Service Letter

SUBJECT FUEL TANK FILLER NECK WATER DEFLECTOR, 1963-64 STATION WAGON MODELS

NUMBER F-1964-2

Fig. 1

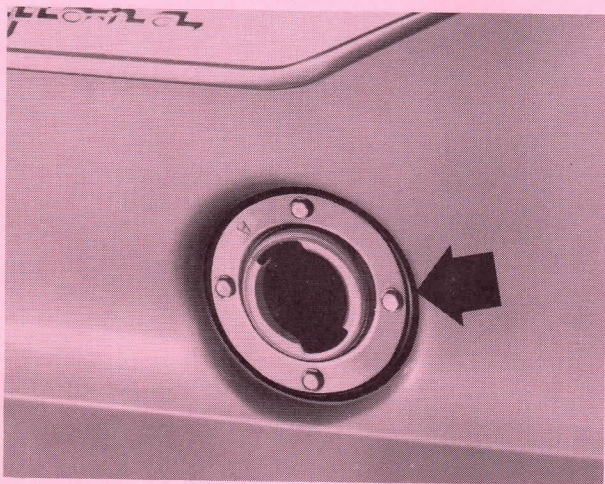
1. Trim off any portion of the filler neck-to-quarter panel rubber gasket that protrudes beyond the lower portion of the filler neck flange to provide clearance between the gasket and the inner edge of the gas cap, see Figure 1. This prevents water from building up in the cap.
2. Install Part Number 1562555, Filler Neck Deflector, onto the filler neck with the small diameter flange toward the car, and the cut-off, slotted portion of the deflector downward. (See Figure 2) Properly positioned, the fuel tank cap, when installed, should enshroud the deflector.
3. If water is present in the fuel system, drain and clean the fuel tank, fuel lines, and fuel pump. Replace the fuel filter element. Clean the carburetor if required. This may be followed by adding some de-icer additive to the fuel.
